**TOWN OF NEWBURGH
PLANNING BOARD
TECHNICAL REVIEW COMMENTS**

PROJECT: RAM HOTELS, INC.
PROJECT NO.: 16-21
PROJECT LOCATION: SECTION 97, BLOCK 2, LOT 37
REVIEW DATE: 10 FEBRUARY 2017
MEETING DATE: 16 FEBRUARY 2017
PROJECT REPRESENTATIVE: MECURIO-NORTON-TAROLLI-MARSHALL

Re: Job No. 4015
Lands of Newburgh Auto Park, LLC
Tax Map Parcel: 97-2-37
Town of Newburgh, Unity Place
Subdivision & Hotel Site Plan
Town of Newburgh Project No. 2016-21

Typical "Downstream Defender" Detail

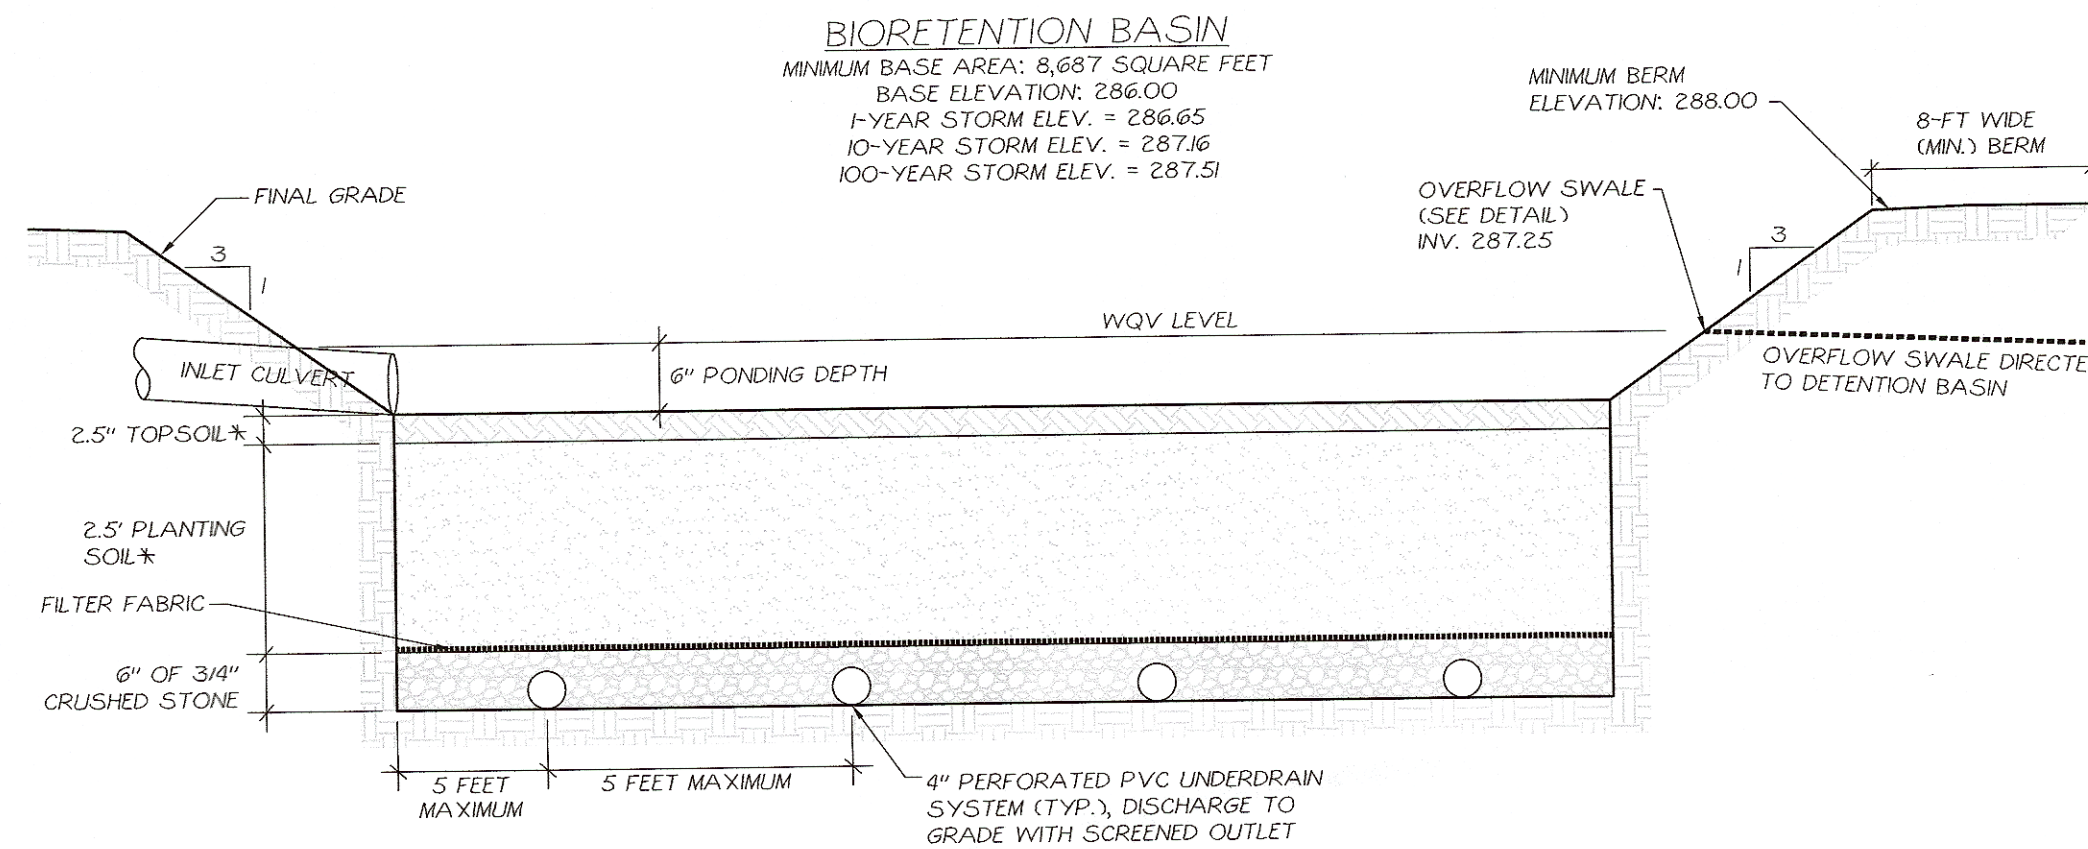
9. Plans should clearly depict where accessible access ramps are to be placed.
10. A proprietary stormwater quality device is depicted in the detail sheets however it is not shown in the plans.

Bioretention Area Detail

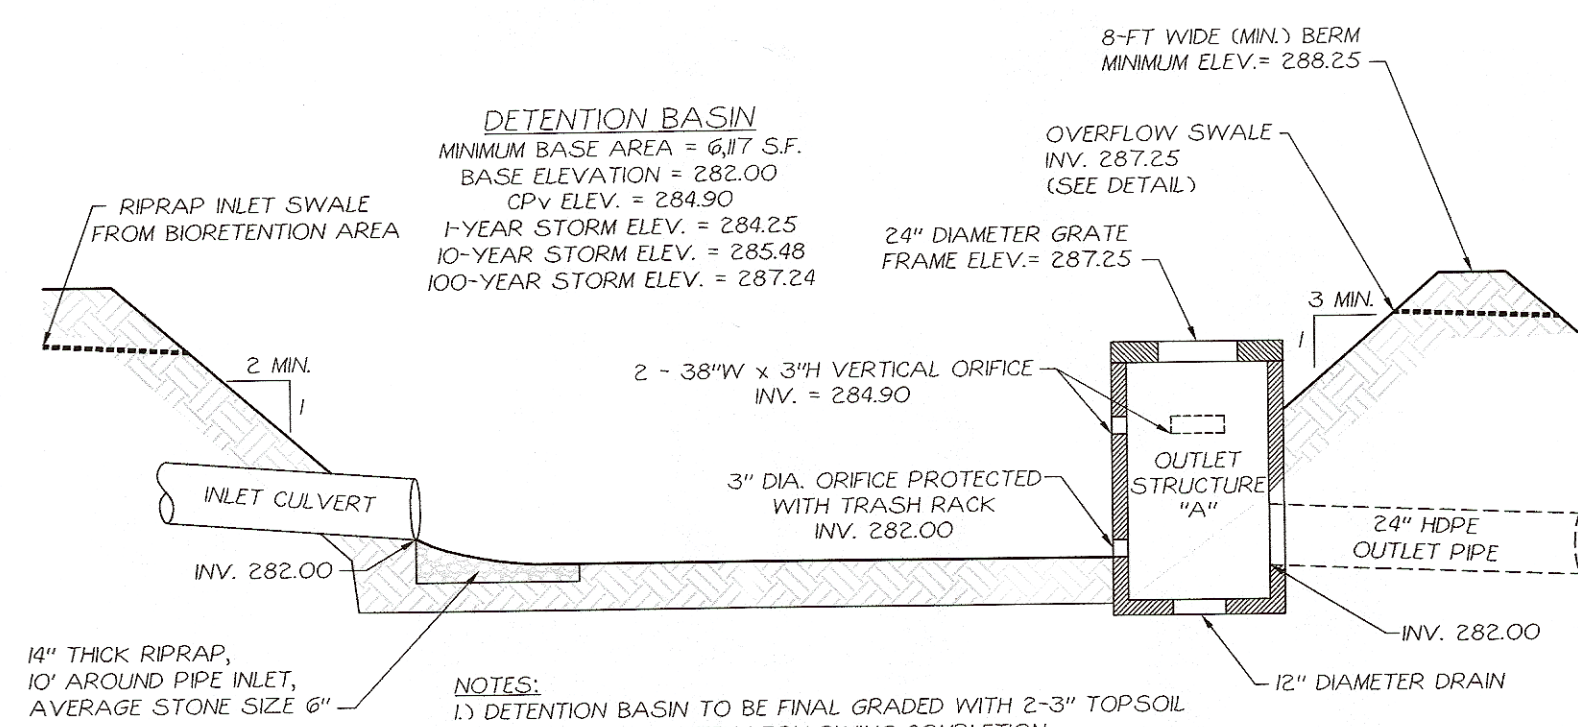
4. Applicant Representative is asked to evaluate point discharge to bio retention area from a 24 inch diameter pipe.
5. A stone diaphragm is required between parking lot runoff areas and bio retention area.
